MEMORANDUM FOR: Ross A. Scarano, Chief
Uranium Recovery Licensing Branch

FROM: Daniel M. Gillen
New Facilities Section
Uranium Recovery Licensing Branch

SUBJECT: REVIEW OF PROPOSED EVAPORATION POND, KERR-MCGEE
NUCLEAR CORPORATION (04008768N01E)

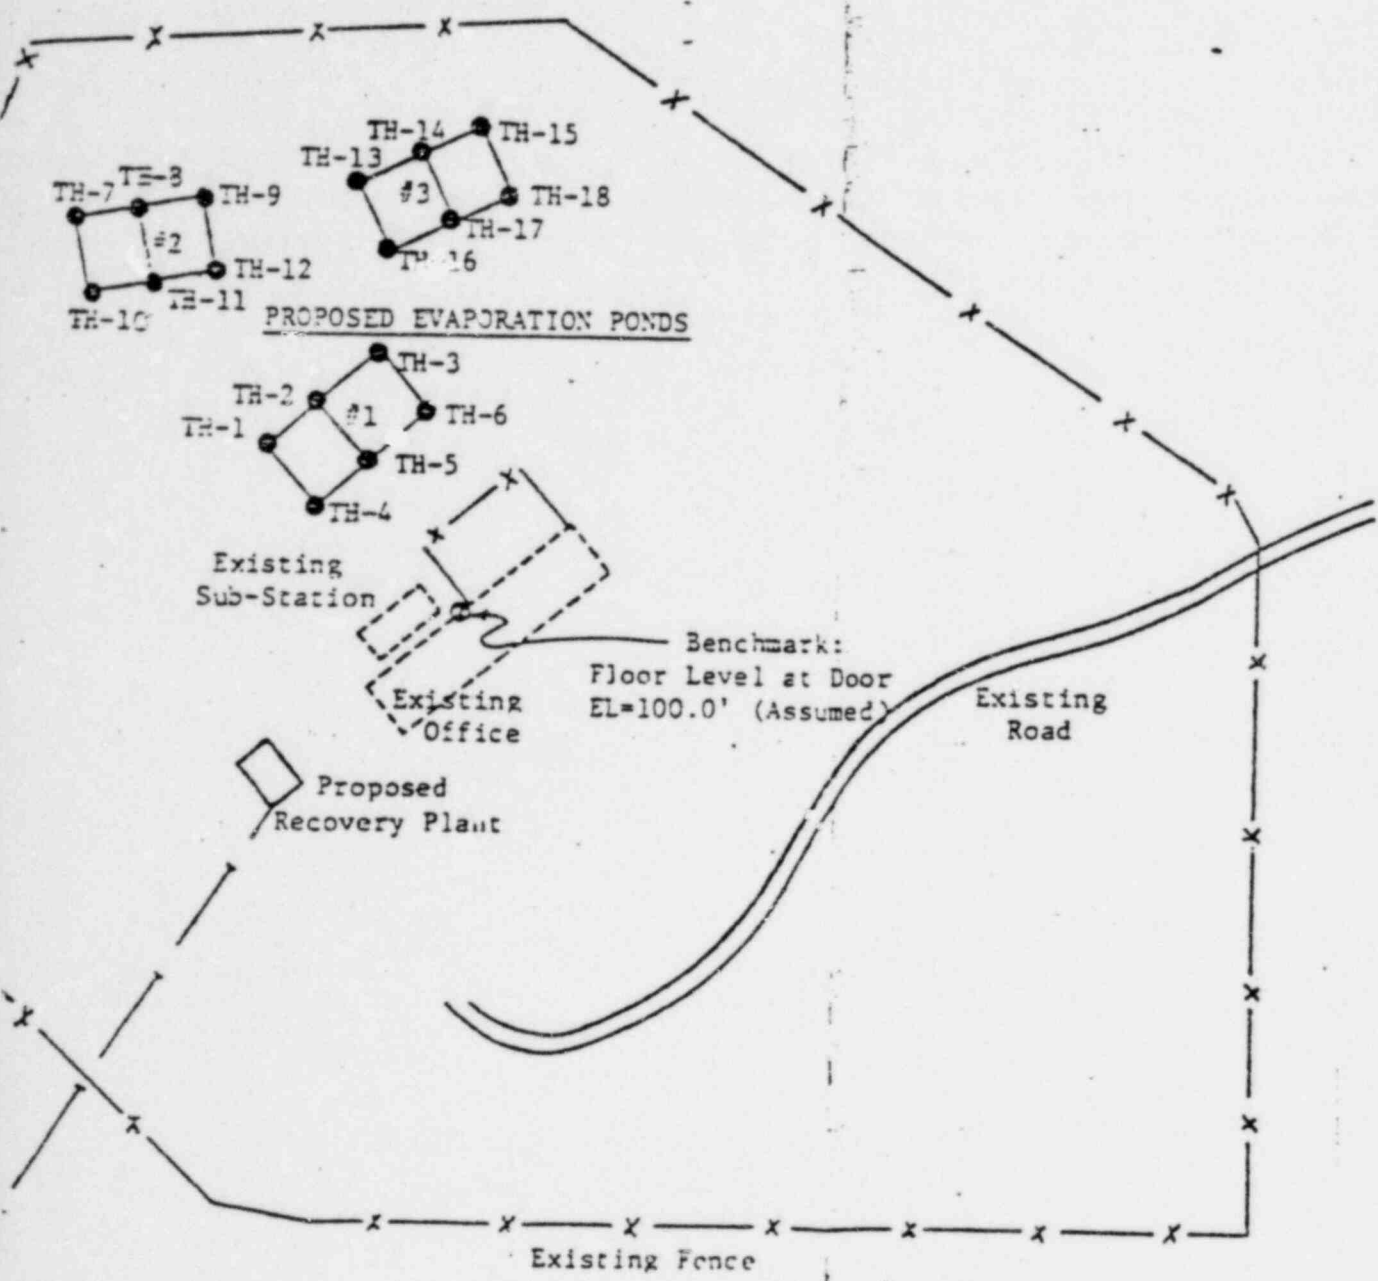
1. Based on the embankment geometry, a review of Kerr-McGee's soil boring data, the compaction specifications, and the proposal of a liner and leak detection system, the embankment design is considered conservative with regard to stability requirements. This conclusion assumes that location No. 2 on Attachment 1 is the site of the ponds.
